**Class 2 Hazardous Waste Storage & Treatment Facility Permit Modification Request for  
Open Burning/Open Detonation and Controlled Destruction Chamber Operations**

Blue Grass Army Depot, Richmond, Kentucky

**EPA ID KY8-213-820-105**

**JUNE 2021**

**Figure E-2a:  
Open Detonation Area  
Monitoring Wells**

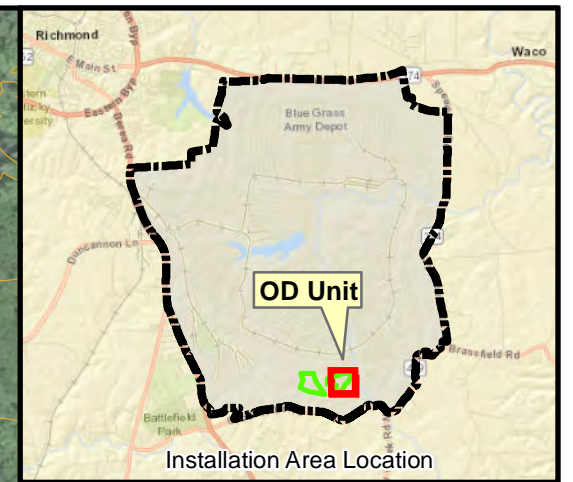
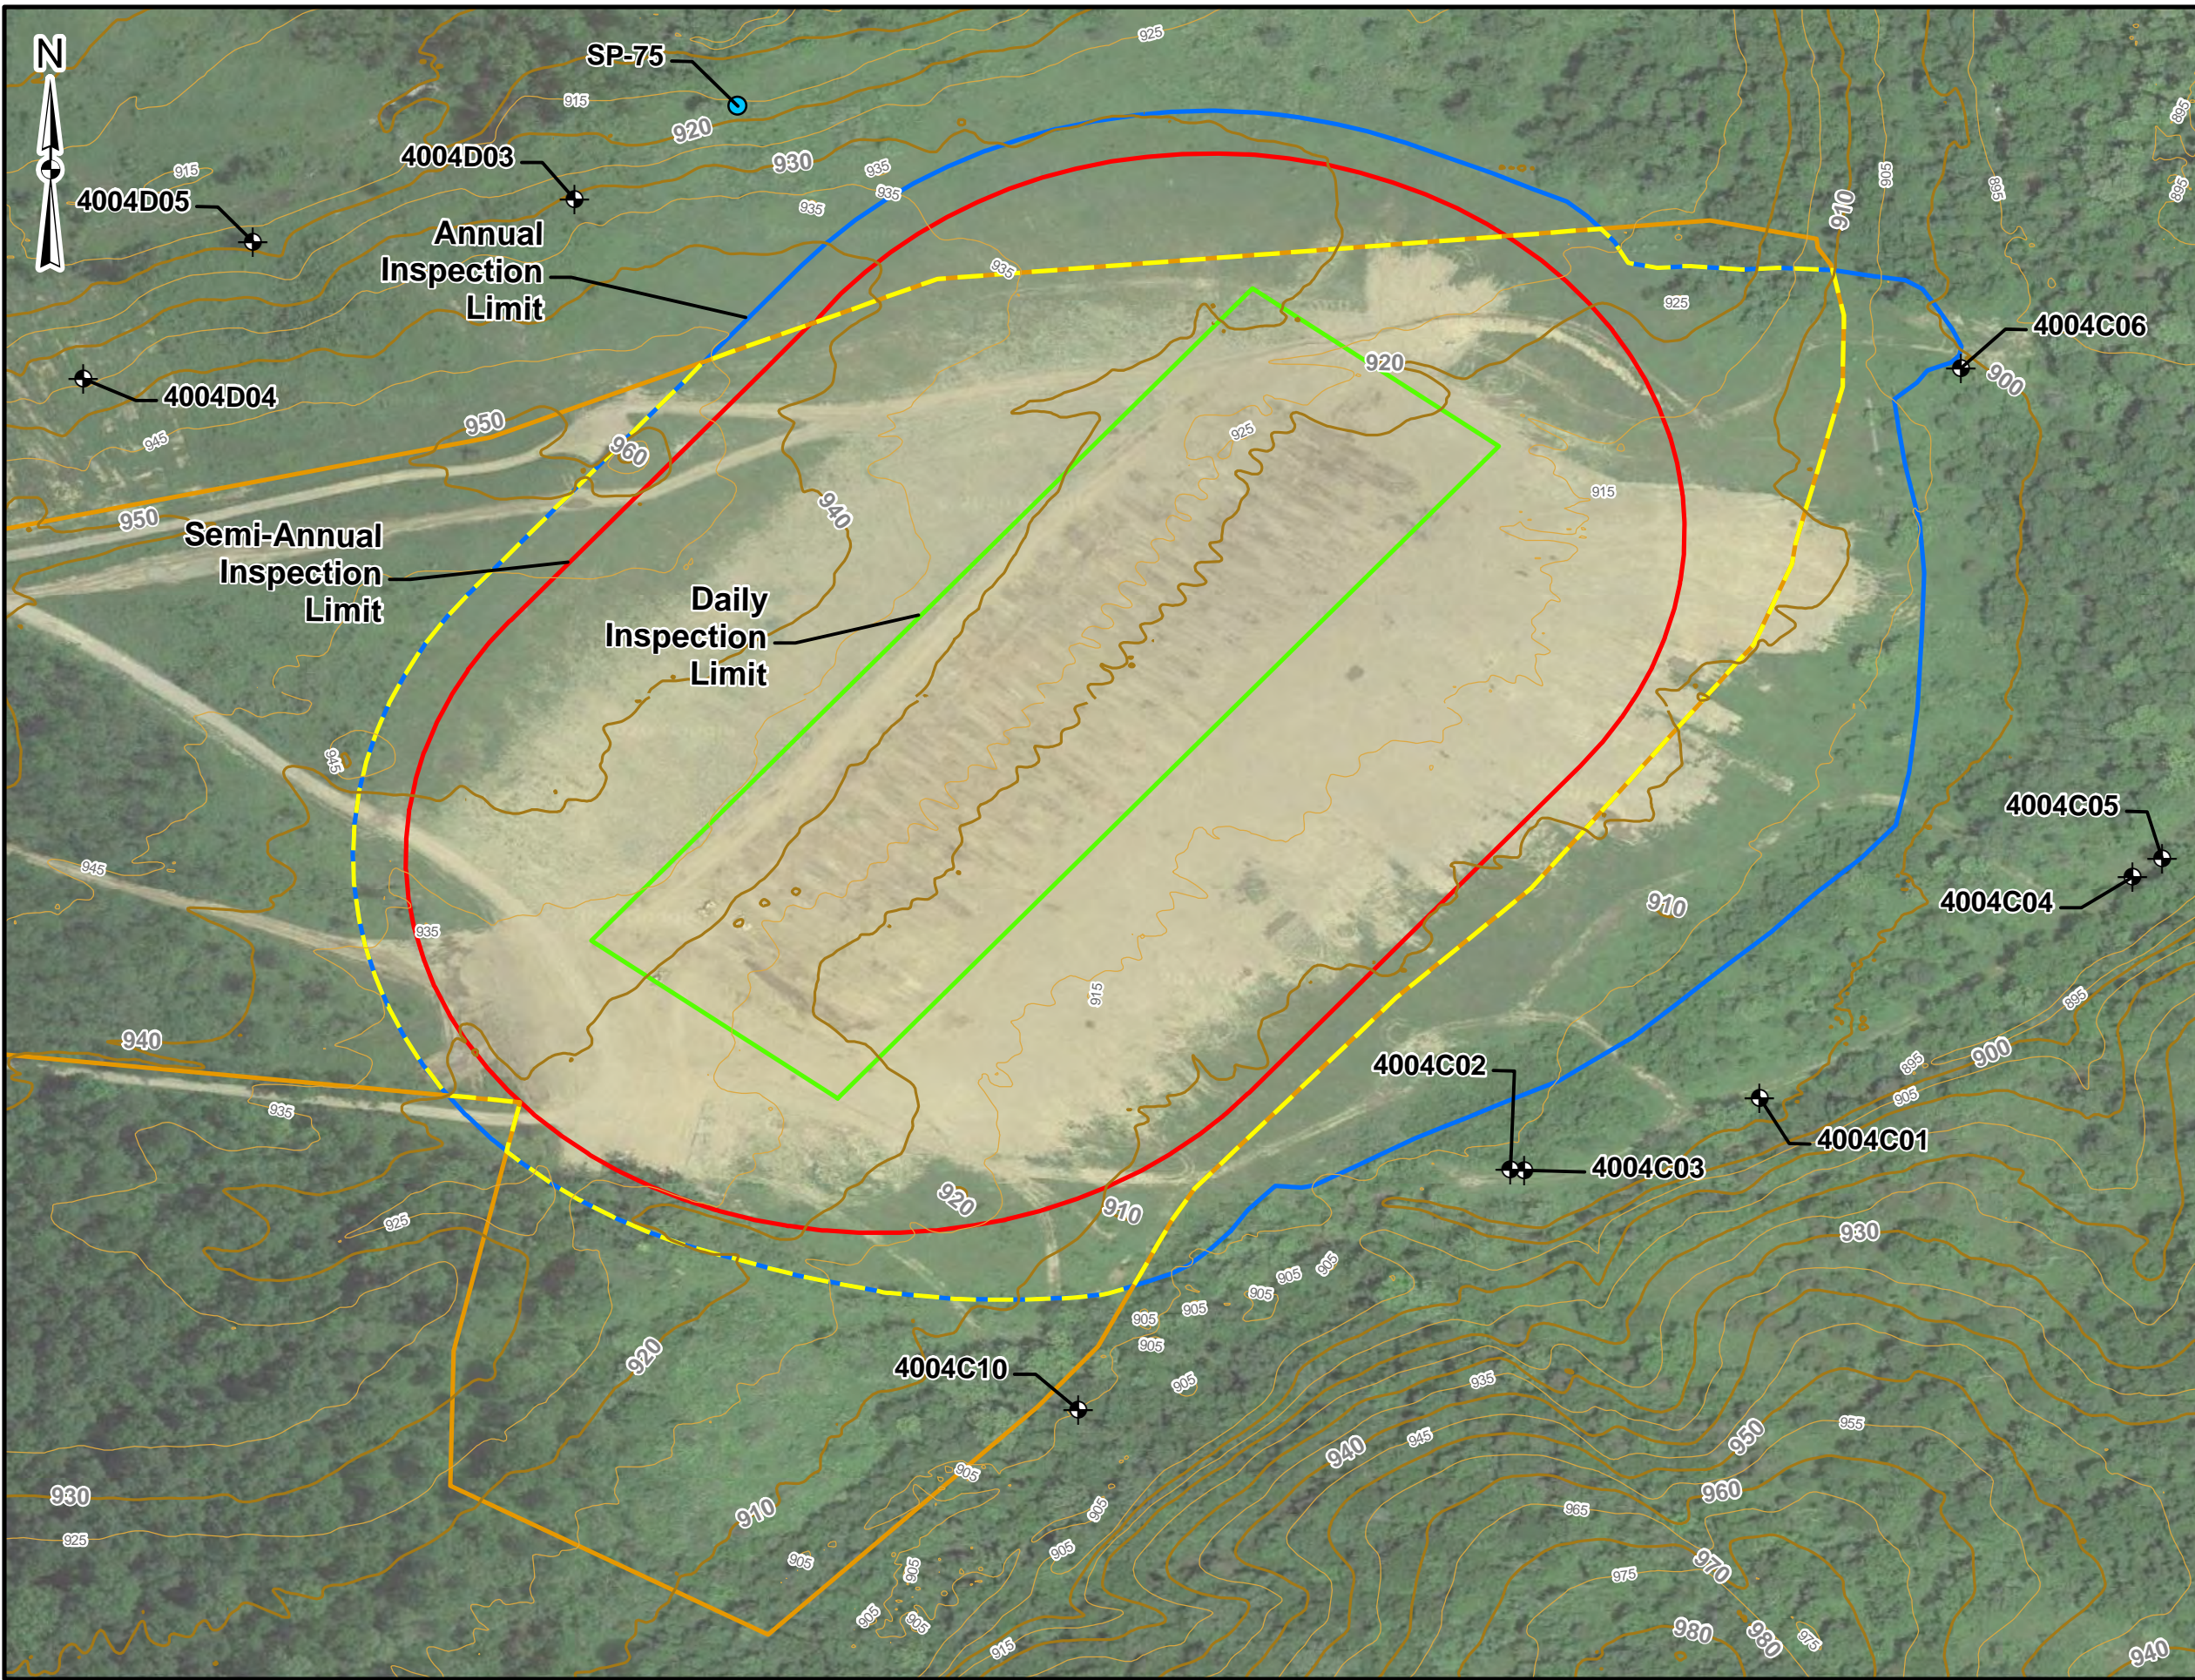
**Figure E-2a** of the current permit identifies the “Approximate Limits of the Open Detonation Permit Area” (i.e., the OD Unit permit boundary). This figure also identifies the daily, semi-annual, and annual inspection limits.

KDEP approved a revised Figure E2a as part of BGAD's response to Notice of Deficiency (NOD1) to Compliance Schedule Items (CSI) #7 and #8, dated May 26, 2020. The permit and inspection boundaries identified on the revised Figure E2a are based on the findings of visual site inspection and modeling, the details of which were included in the Final Management Plan for Open Detonation Ejecta, May 2020, submitted in accordance with the requirements of CSI 8. Specifically, the results of visual site inspection and modeling supported a finding that ejecta from ongoing operations remain within these boundaries. Ejecta observed outside of these boundaries was observed to be associated with historical operations. The combination of visual observation and modeling provide the justification for the revised boundaries.

This PMR requests that the current Figure E2a be replaced with the KDEP-approved Figure E2a included as **ATTACHMENT 2**.

Replace Figure E-2a.

**Figure E-2b:  
Open Burn Area**

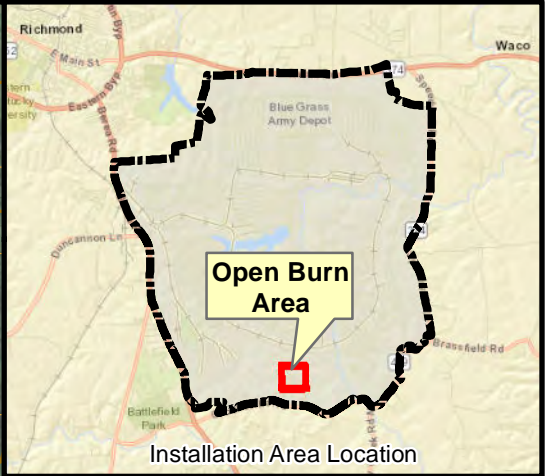
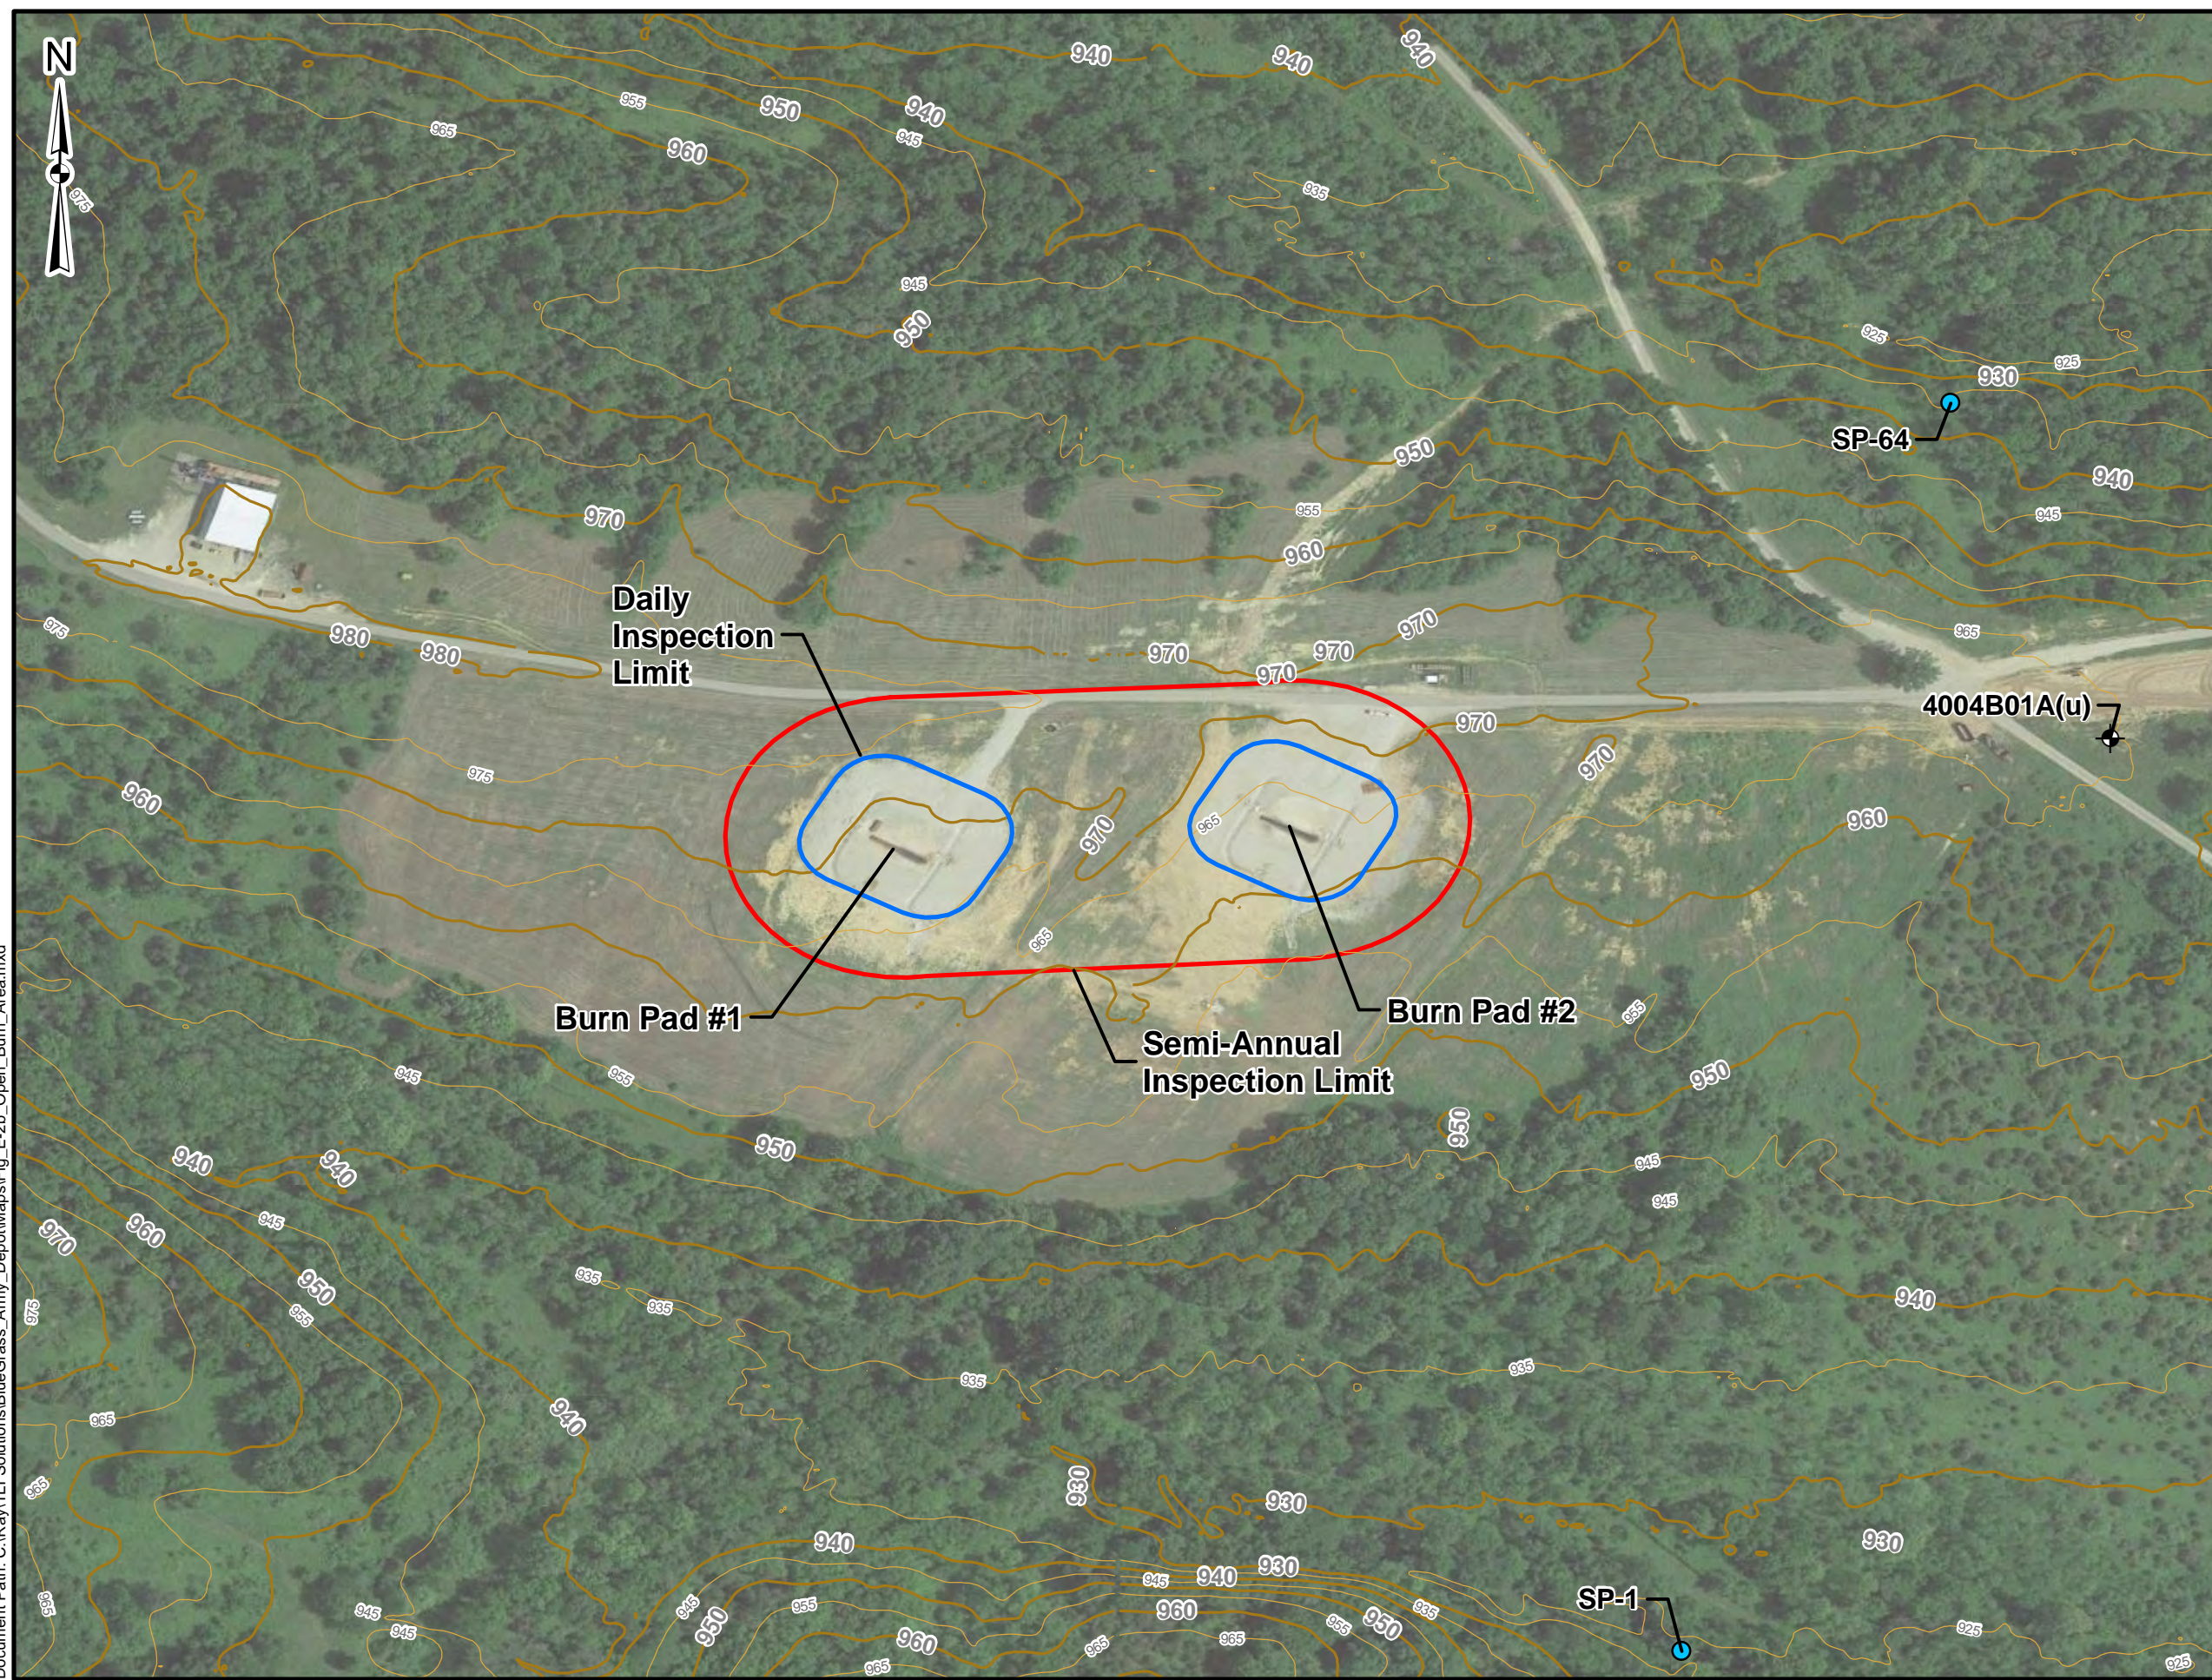
**Figure E-2b** of the current permit identifies the daily and semi-annual inspection limits of the Open Burn Unit.

KDEP approved a revised Figure E2b as part of BGAD's response to Notice of Deficiency (NOD1) to Compliance Schedule Items (CSI) #7 and #8, dated May 26, 2020. The semi-annual inspection boundary identified on the revised Figure E2a is based on operator knowledge and results of the initial inspections that encompassed the boundaries identified in the original Figure E2b. Specifically, that operations at the OB unit impact only a very limited area surrounding each pan and that the original semi-annual inspection area was unnecessarily large.

This PMR requests that the current Figure E2b be replaced with the KDEP-approved Figure E2b included as **ATTACHMENT 3**.

Replace Figure E-2b.
